STATE OF MONTANA, NATURAL RESOURCE DAMAGE PROGRAM

**RE: NRDP Comments on EPA's Position on the Use of Onsite Material as General Fill
at Butte Priority Soils Operable Unit of the Silver Bow Creek/Butte Area
Superfund Site**

General Fill Cross Section

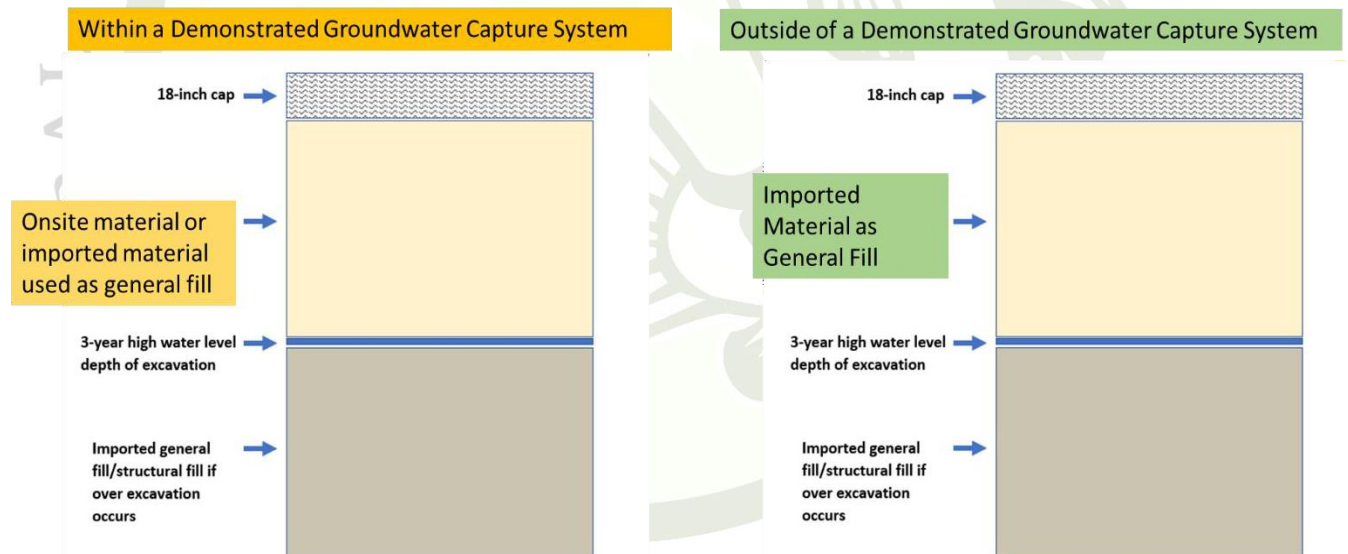
By only allowing this new higher contaminant concentration general fill within a “demonstrated groundwater capture system,” it appears that EPA agrees that this type of higher contaminant concentration general fill, if used without well-defined and strict location specific controls, is a risk to groundwater from irrigation infiltration, precipitation infiltration, and groundwater saturation. NRDP agrees that these materials are leachable and a risk to water resources of the State, and relying on engineered controls is not protective of the resource.

The 3-year groundwater level criterion was not established in the CD with this scenario in mind. Using the high 3-year groundwater level criteria now for placement of this new category of higher contaminant concentration general fill means that it could be saturated on average every 4 years by groundwater and perhaps more frequently. Does EPA have an analysis that demonstrates that this criterion is protective? If not, then a more protective frequency should be considered, such as 7- or 10-year high groundwater.

The State does not agree that additional groundwater contamination loading sources are acceptable now or in the future, which is implicit in the "capture zone" criteria (i.e., it can contaminate groundwater because groundwater will be captured somewhere else). Allowing further contamination to groundwater is not acceptable to the State.³

We also have concerns with the feasibility of relying on a "demonstrated" groundwater capture zone to protect the State's groundwater resources. How will the groundwater capture zone be determined in order to guide the placement of this new category of higher contaminant concentration general fill? What guidance will EPA use to determine groundwater capture zones? How can the groundwater capture zone be adequately defined to explain the placement of onsite fill for current projects when future remedial elements for groundwater capture are still years away from design, implementation, and effectiveness determination?

The figure entitled, “General Fill Cross Section” shows an 18-inch cap over the “onsite fill,” which appears to be a requirement of the Position. Capping with 18 inches of soil does not provide adequate protection from infiltration and leaching to groundwater in Butte, MT. For the design of the 18-acre Evapotranspiration Cover System for the Parrot Project, NRDP modeled this infiltration contaminant transport mechanism, which led to the design and construction of a 36-inch-thick cap, made of very specific soils to interrupt and address the risks for this infiltration pathway.
